White Sulphur Springs Airport

Standards Review Nonstandard Conditions & Notes

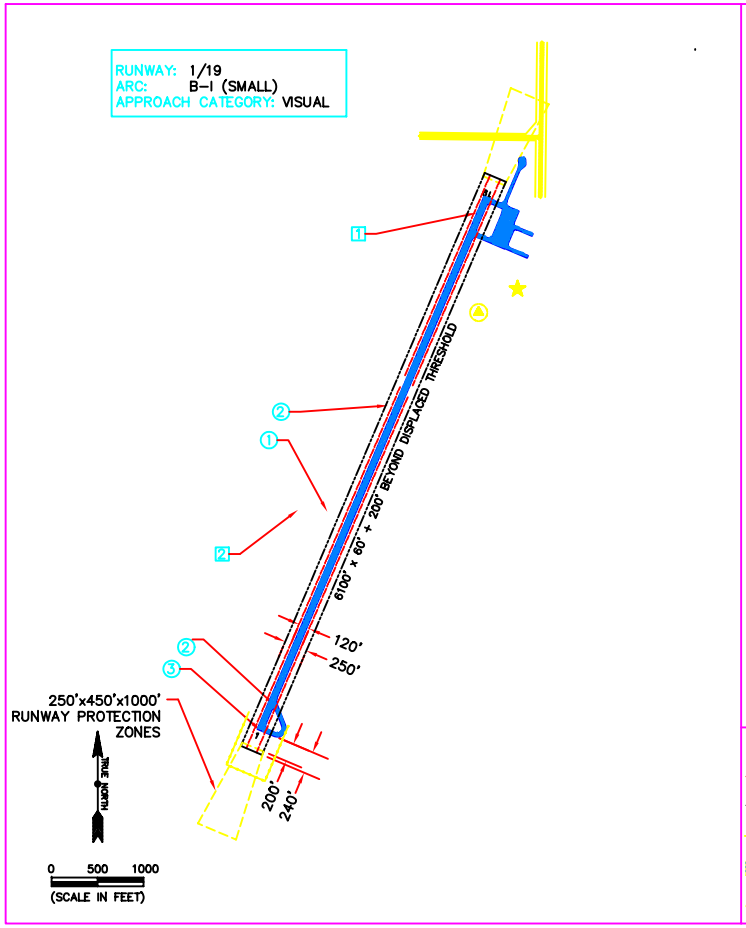
Runway 1 / 19

1. RUNWAY LENGTH RECOMMENDED TO MEET 100% OF SMALL AIRCRAFT NEEDS (6,230 FT).
2. RUNWAY LIGHTS ARE IN VARIOUS STATE OF DISREPAIR IN THE VICINITY OF THE CROSSWIND RUNWAY INTERSECTION & THE 1 END.
3. LIGHTS WITH THE WRONG COLOR GLOBE.

Taxiways & Aprons

1. MISSING REFLECTOR.
2. MISSING PORTION OF FENCELINE.
